TECHNICAL EVALUATION REPORT

**PRIMARY COOLANT SYSTEM
PRESSURE ISOLATION VALVES**

WISCONSIN PUBLIC SERVICE CORPORATION
KEWAUNEE UNIT 1

NRC DOCKET NO. 50-305

Figure 1. Valve Configurations Designated by the NRC To Be Included in This Technical Evaluation

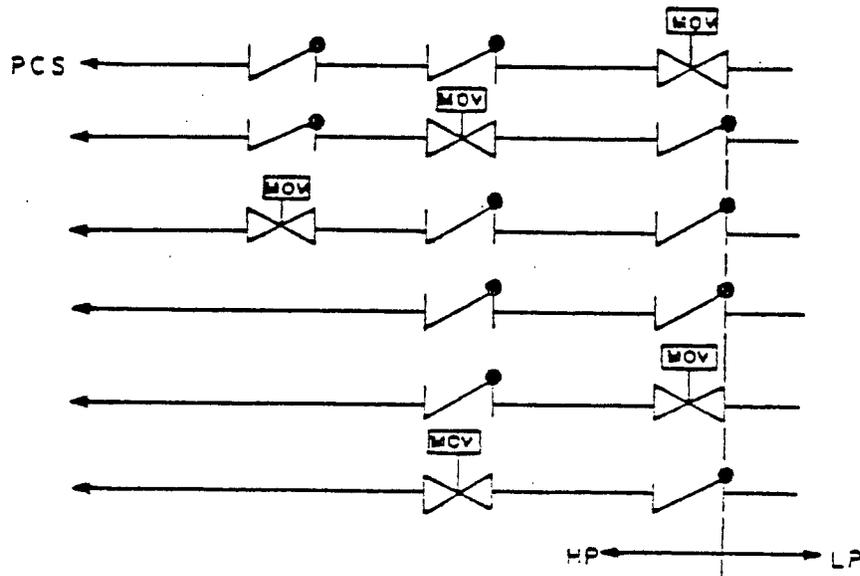
It has been determined that the Residual Heat Removal/Low-Head Safety Injection system in Kewaunee Unit 1, incorporates valving in one of the configurations (identified in Figure 1) designated by the NRC as a valve configuration of concern. Moreover, based on the previously docketed information and drawings made available for FRC review, FRC found that the crossover line between the Loop B cold-leg Accumulator and the Residual Heat Removal/Low-Head Safety Injection Systems lines also incorporates a valve configuration of concern. Thus, if the licensee's review of the valving configuration contained in this crossover line confirms FRC's finding, then valve configurations of concern exist in two systems of Kewaunee Unit 1 and incorporate the valves listed in Table 1.0.

If WPS modifies the Plant Technical Specifications for Kewaunee Unit 1 to incorporate periodic testing (as delineated in Section 2.2) for the check valves itemized in Table 1.0, then FRC considers this an acceptable means of achieving plant compliance with the NRC staff objectives of Reference 1.
